The following Addendum forms part of the Contract Documents for the Canada Centre for Inland Waters (Project Number R.073578.001). The following changes, additions or deletions shall be made to the following documents as indicated and all other Contract Documents shall remain the same.

This Addendum Number 01 contains 2 written pages, and 6 attached drawings example: (ADD-01-SKM-001, ADD-01-SKM-002, ADD-01-SKM-003, ADD-01-SKM-004, ADD-01-SKM-005, ADD-01-SKM-006).

DRAWING #: ADD-01-SKM-001

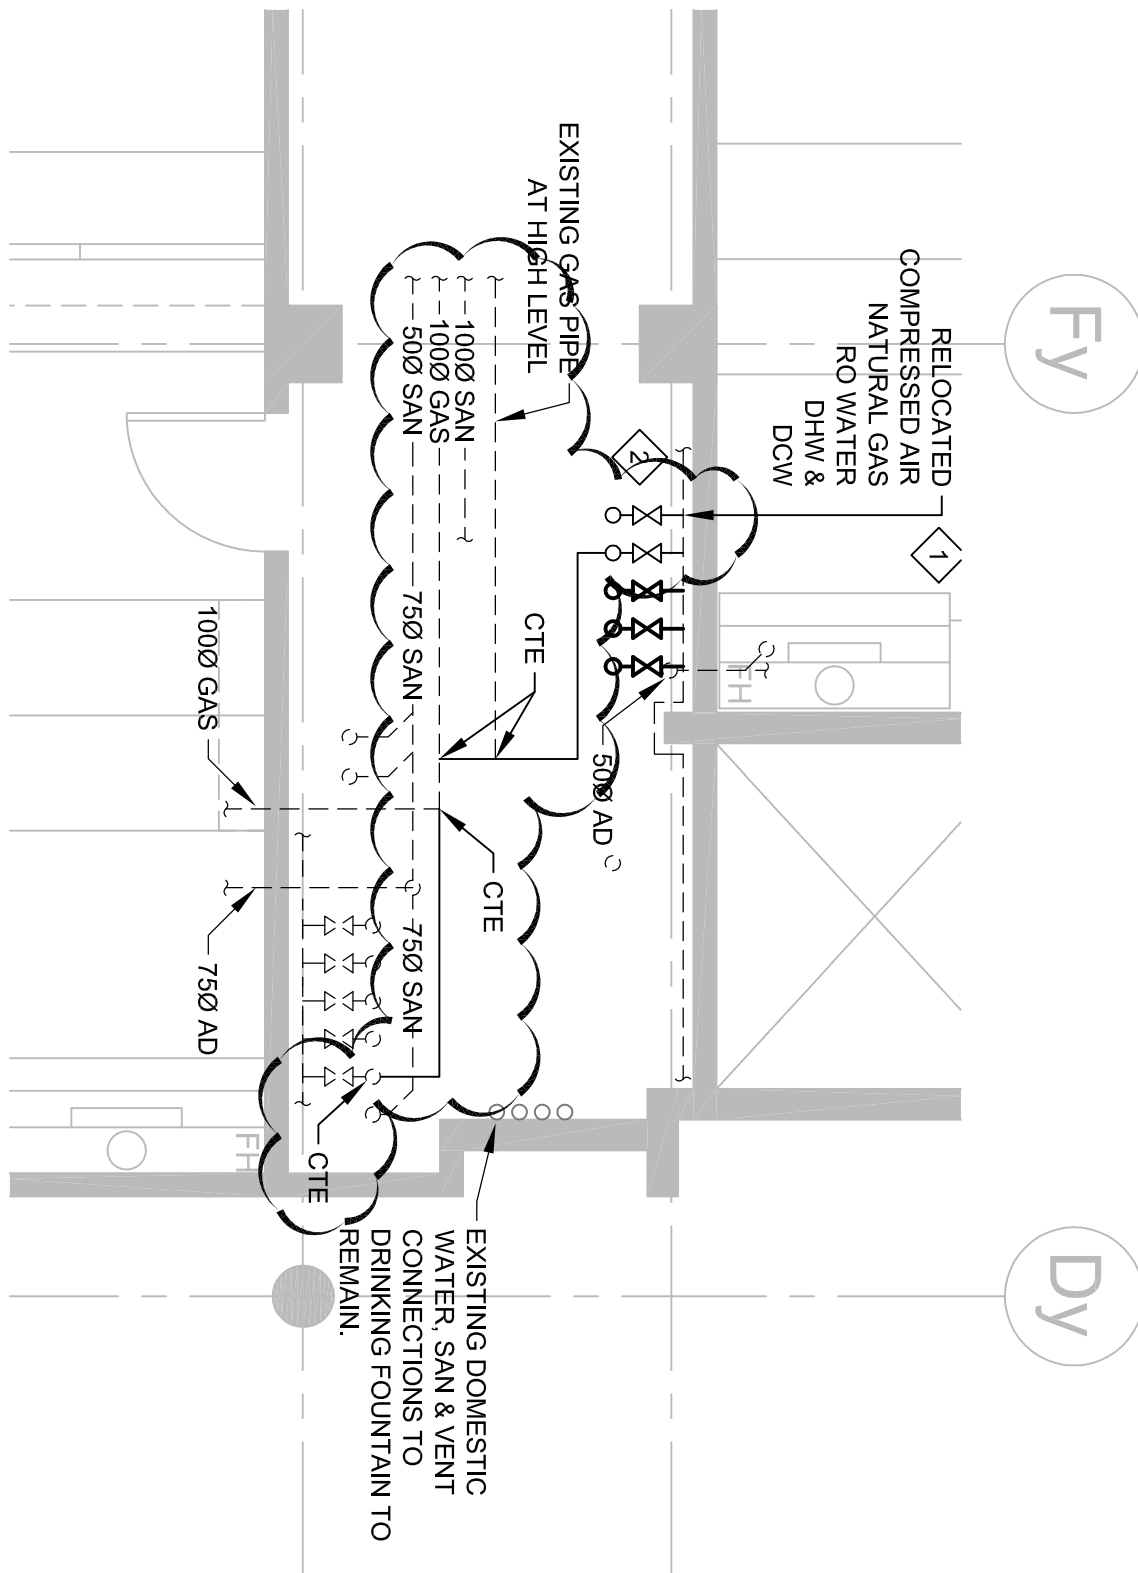
- .1 Drawing M1.10 – A&L Building Exhaust Upgrade Fourth Floor – HVAC & Plumbing Plan - Demolition
  - .1 Clarified demolition and new routing of gas piping as detailed on SKM-001, dated 2015-12-03, attached to and forms part of this Addendum.

DRAWING #: ADD-01-SKM-002

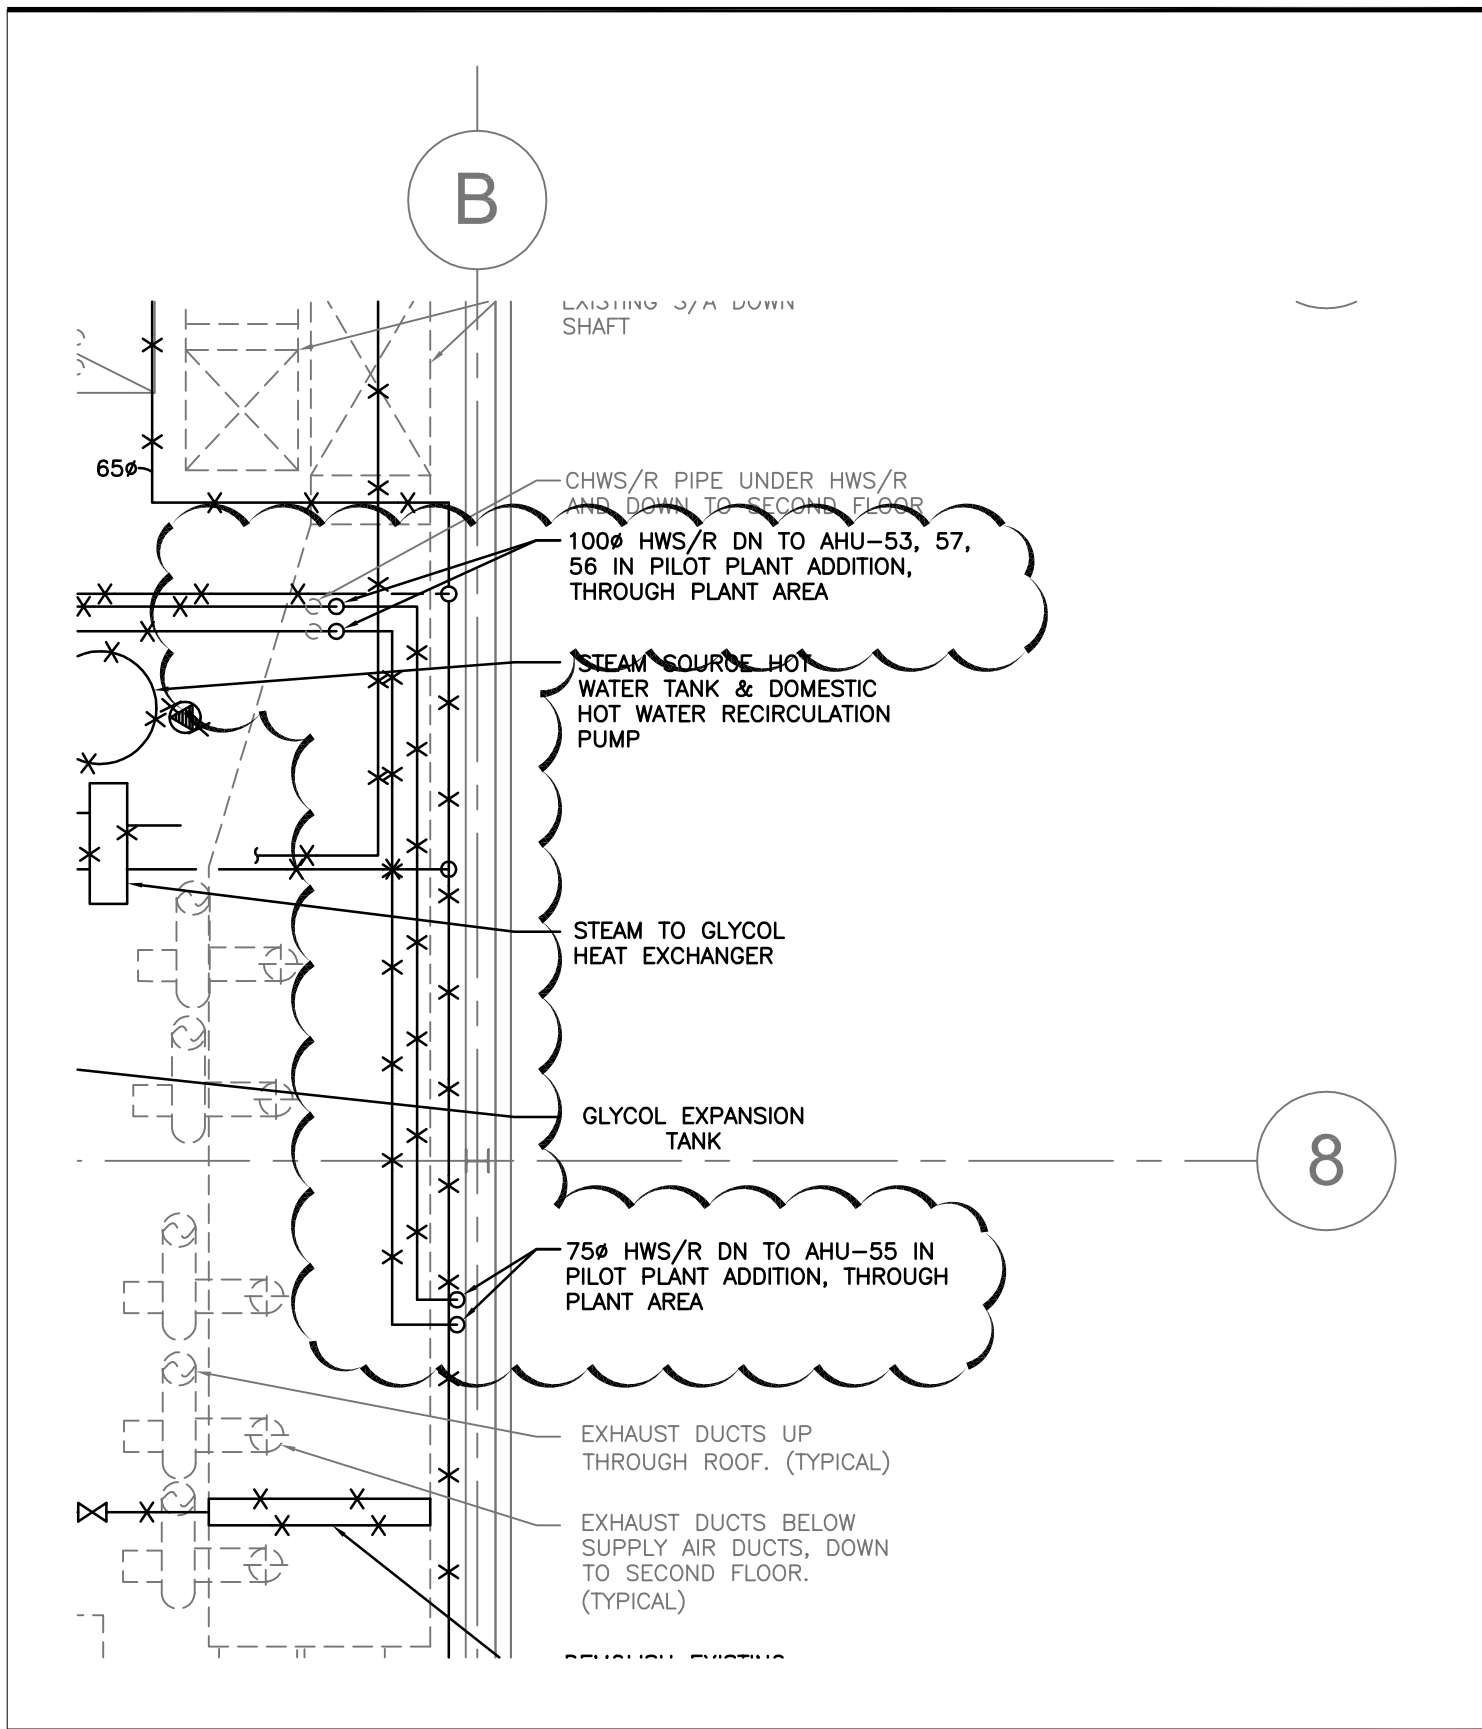
- .2 Drawing M2.10 – A&L Building Exhaust Upgrade Fourth Floor – HVAC & Plumbing Plan
  - .1 Clarified demolition and new routing of gas piping as detailed on SKM-002, dated 2015-12-03, attached to and forms part of this Addendum.

DRAWING #: ADD-01-SKM-003

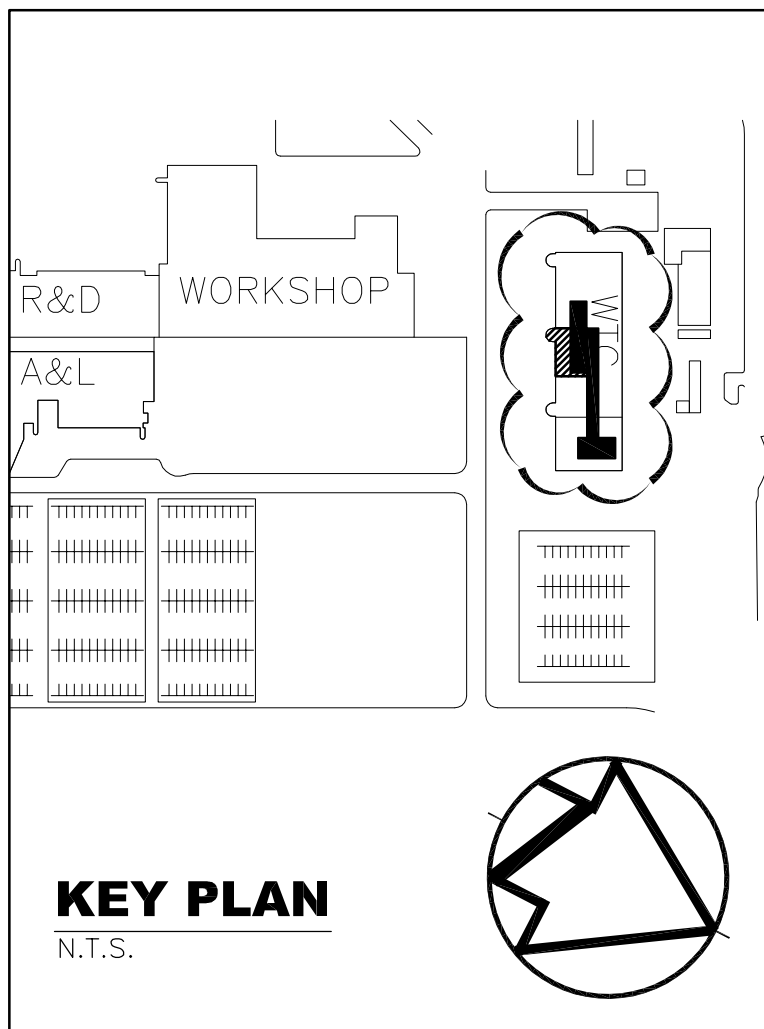
- .3 Drawing M1.33 – WTC Building Heating System Service Penthouse Mechanical Plan - Demolition
  - .1 Demolish existing water piping as detailed on SKM-003, dated 2015-12-03, attached to and forms part of this Addendum.

DRAWING #: ADD-01-SKM-004

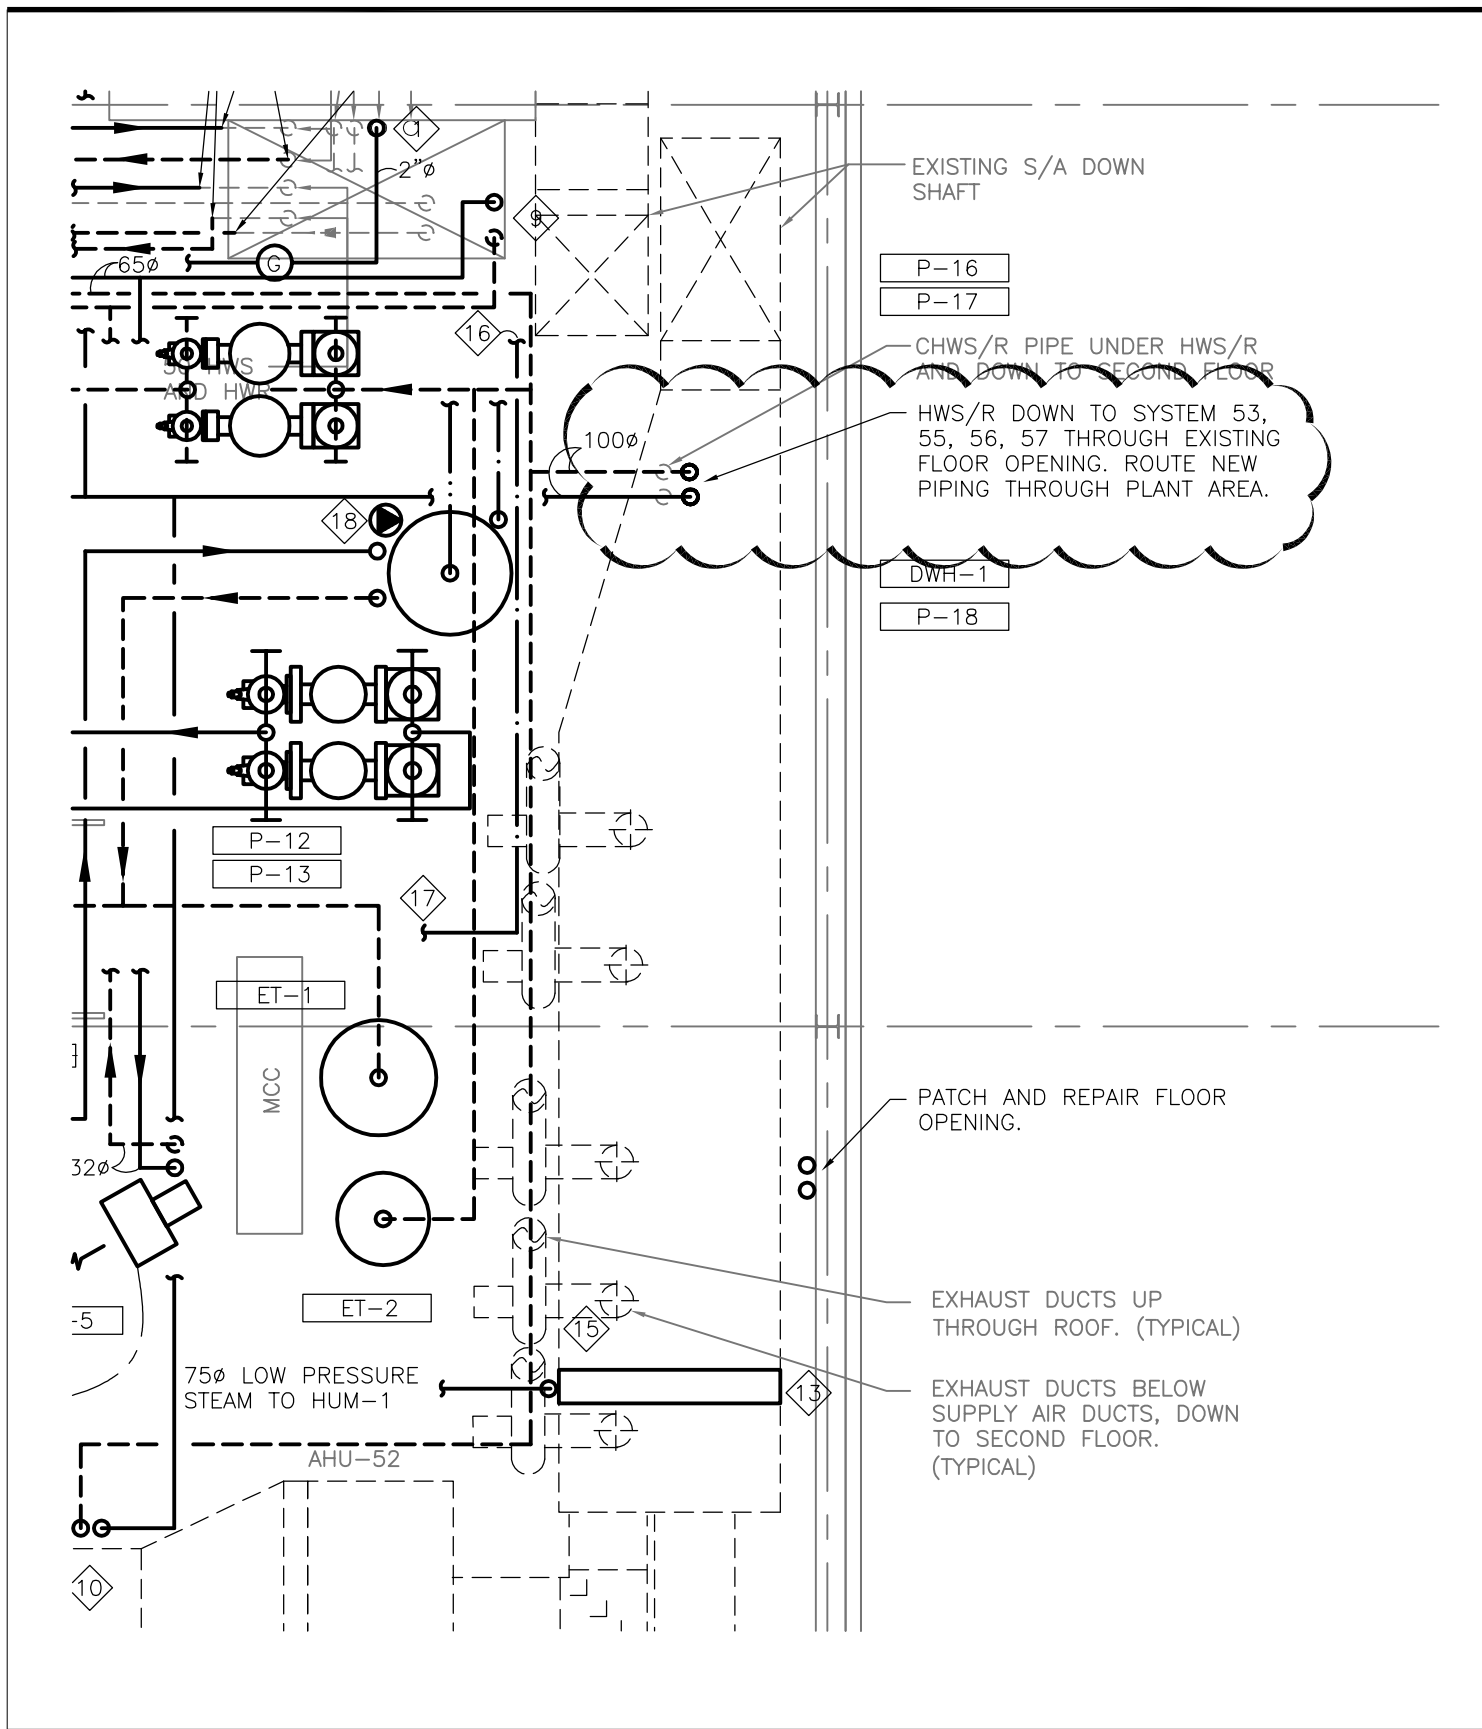
- .2 Extent of demolition to plant addition shown as per SKM-004, dated 2015-12-03, attached to and forms part of this Addendum.
- .4 Drawing M2.33 – WTC Building Heating System Penthouse Mechanical Plan

DRAWING #: ADD-01-SKM-005

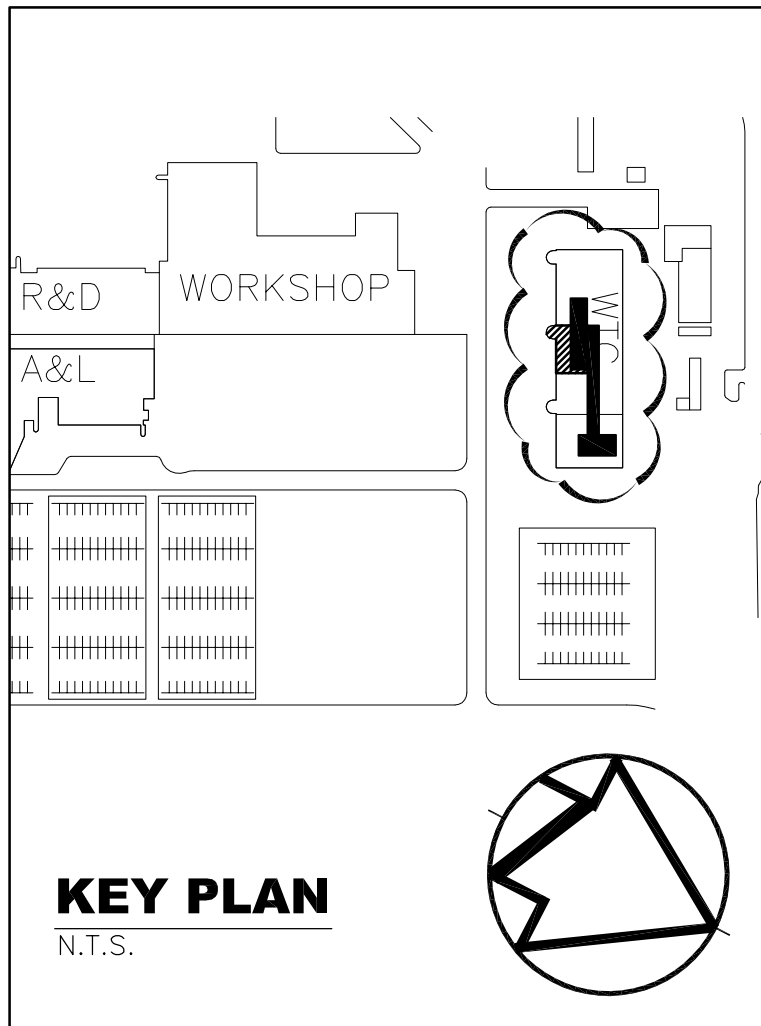
- .1 Provide new piping heating water piping as detailed on SKM-005, dated 2015-12-03, attached to and forms part of this Addendum.
  - .2 Extent of new piping to plant addition shown as per SKM-006, dated 2015-12-03, attached to and forms part of this Addendum.
